RESPONSE TO NRC 6/28/77 REQUEST FOR ADDL INFO
ON INSERVICE INSPECTION PROGRAM: W/ATTACHED
ENCLOSURES 1 thru 5DOCKET NO. 50-272
RECEIVED WITH LETTER DATED 10/11/77
ACCESSION # 773000214

ADDITIONAL INFORMATION FOR REVIEW OF PROPOSED INSERVICE INSPECTION AND TESTING PROGRAMS SALEM NUCLEAR GENERATING STATION

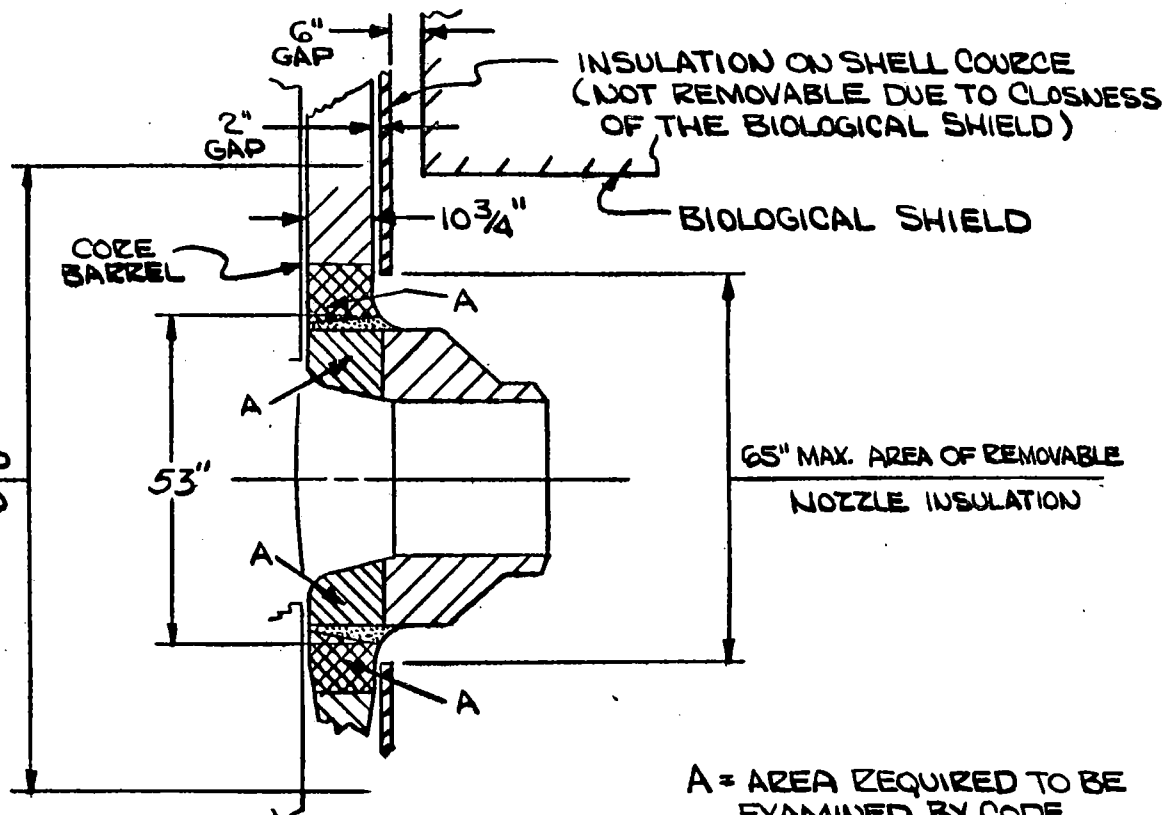
Volumetric examination will not be performed when the Core Barrel is in place due to inaccessibility. The examinations will be performed when the core barrel is removed during the inspection interval. These welds are identified as 27.5-1110-1, 27.5-RPV-1120-1, 27.5-RPV-1130-1 and 27.5-RPV-1140-1 in the examination plan.

As indicated in PSE&G Sketch No. 8-15-77 attached, the Core Barrel covers the weld area when it is in place. Since all weld examinations are performed from the inside surface using an mechanized inspection device, these welds are inaccessible at this time. Examinations cannot be performed from the outside surface due to the area being covered by insulation on the shell of the weld and the configuration of the weld joint on the nozzle side of the weld. The insulation on the shell portion of the reactor vessel is not designed for removability and to remove it would require the cutting away of the insulation support rings from the vessel.
